Project	Northampton Gateway
Client	West Northamptonshire Council
Document Title or Subject	Transport Addendum Review
Document Reference	WNC-TA-160
Revision Reference	C
Prepared by	A Carpenter
Date	09/06/2025

West Northamptonshire Council (WNC) has commissioned Pell Frischmann to undertake a technical review of the Transport Assessment Addendum (TAA) (Doc Ref: ADC3519-RP-B) submitted in support of an amendment to a DCO application (ref: S.I. 2019 No. 1358) for the Northampton Gateway SRFI scheme.

Figure 2 Proposed Mitigation Strategy - Partially Signalised Roundabout

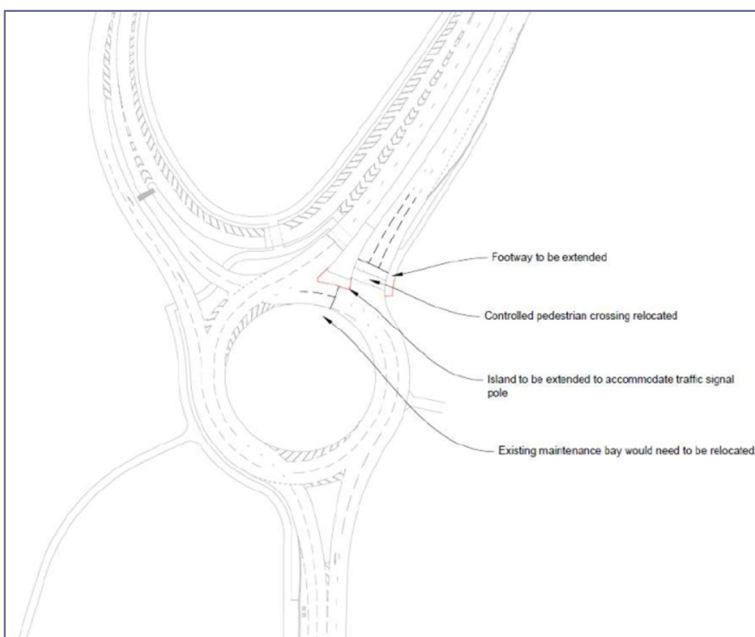
Figure 2 shows that the mitigation proposals are to partially signalise the roundabout at the northern point of the circulatory carriageway and the southbound entry arm.

- The repositioning of the maintenance layby is in the vicinity of the hatched markings. The proposed detailed design will therefore need to include their removal and relocation. (RSA problem 2.4)

- The location of the crossing in the circulatory signals may impede the flow of traffic on the roundabout causing traffic to block. The new signals on the roundabout only allow for 1 HGV to wait before the outer lane would become blocked. The RSA (problem 2.1) recommends the use of yellow box hatching; however, motorists may not comply with the hatching, meaning vehicle blocking could still be an issue.

- The existing junction has splay kerbs on the internal radius. Additional protection to the signals to prevent vehicles mounting the kerb may be required. Using kerbs that are shaped to prevent vehicle mounting, for example Half battered type 2 or Trief kerbs would be preferable.

- The raised landscaping on the central island may still cause some visibility issues across the central island. See comment in the assessment of the existing roundabout.

- The swept path analysis shows all movements can be accommodated for the max legal heavy goods vehicle.

- The tracking drawing NGW-BWB-HGN-SM7A-DR-CH-0130 mentions “HGVs are only permitted to exit onto roundabout in specific circumstances”. Whilst there is a height restriction barrier to restrict HGVs, it is noted that the carriageway appears to be designed to accommodate HGVs.

Figure 3 Applicant Model Structure

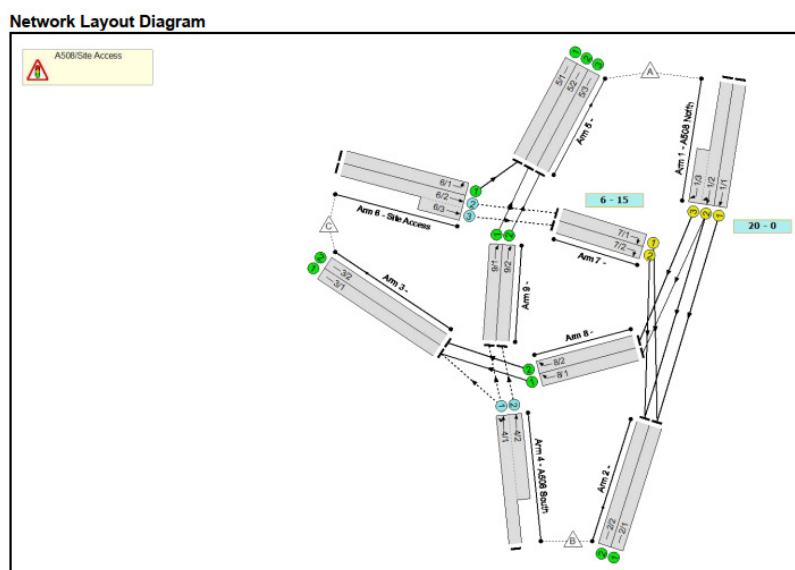
The internal circulatory arms within the model do not include entry or exit arms and as such the model will not register the potential impact of link connectors. For example a link connector from Arm 1 and 7 joining arms 4 and 8. Although this is unlikely to have a material impact on the capacity assessment it would usually be considered good practice to structure a signalised roundabout as shown in Figure 4.

There is no provision in the model for the western TOUCAN crossing. Although it is recognised that demand for this is currently unknown, it is likely that following the build out of the wider SRFI site that the crossing will be called during peak periods.

It is recommended that the model be updated to include internal exit arms.

It is recommended that the model be updated to include the western TOUCAN crossing.

Figure 5 Staging Diagram

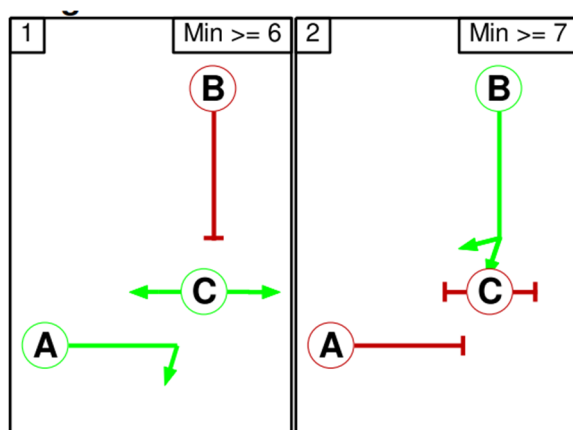
The staging is appropriate for this type of junction; however, it is recommended that the TOUCAN crossing on the western arm be incorporated into the model. The exclusion of this crossing means that any potential queuing or blocking back onto the junction cannot be measured. Although it is recognised that the applicant has confirmed that the omission of the crossing is due to the assumption of it having low demand, it is noted that sustainable travel options will be encouraged and the crossing provide direct access to a bus stop and a segregated cycle facility. Accordingly, the model should be updated to include this crossing with it potentially being run every second or third cycle to simulate the pedestrian demand.

It is recommended that the TOUCAN crossing on the western arm be incorporated into the model.
